From: TAVASSOLI Kamran (AREVA) [kamran.tavassoli@areva.com]
Sent: Monday, October 03, 2011 1:41 PM
To: Hardin, Kimberly
Cc: BONDRE Jayant (AREVA)
Subject: editorial correction for CoC 9302, Rev. 3
Attachments: Correction of Rev No.pdf

Pursuit our phone conversation, please see the proposed editorial changes for CoC 9302, Rev. 3.

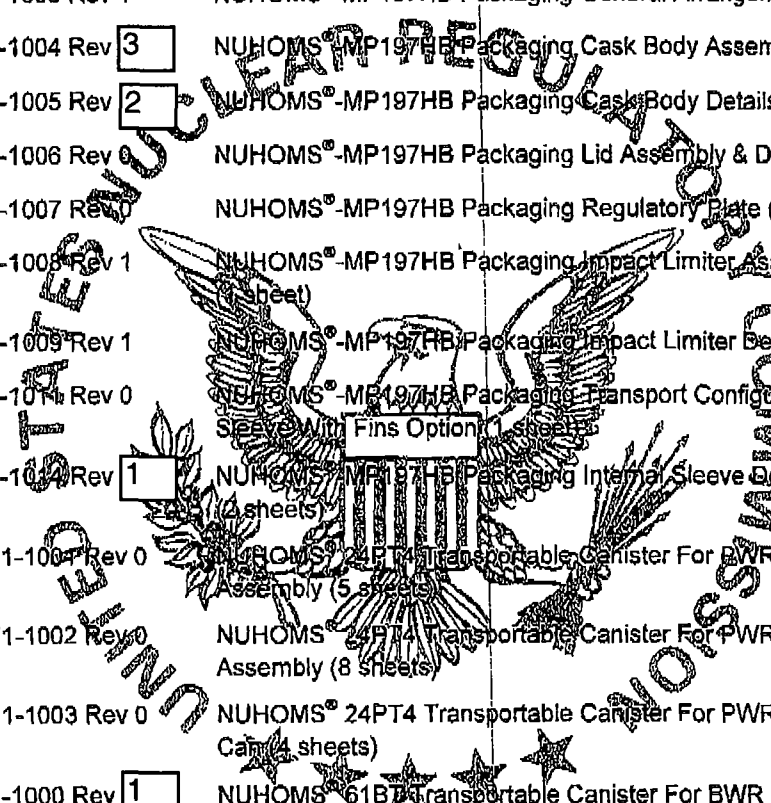
- 1) Condition 5.(a)(5), page 7 of 17 through page 9 of 17: Revision number of drawings for MP197HB should be corrected based on the revision numbers in the SAR. Please see the attached file for the correct revision numbers.

- MP197HB-71-1001 Rev 1 NUHOMS®-MP197HB Packaging Transport Configuration (2 sheets)
- MP197HB-71-1002 Rev 3 NUHOMS®-MP197HB Packaging Parts List (2 sheets)

- MP197HB-71-1003 Rev 1 NUHOMS®-MP197HB Packaging General Arrangement (1 sheet)
- MP197HB-71-1004 Rev 3 NUHOMS®-MP197HB Packaging Cask Body Assembly (1 sheet)

- MP197HB-71-1005 Rev 2 NUHOMS®-MP197HB Packaging Cask Body Details (3 sheets)
- MP197HB-71-1006 Rev 0 NUHOMS®-MP197HB Packaging Lid Assembly & Details (1 sheet)
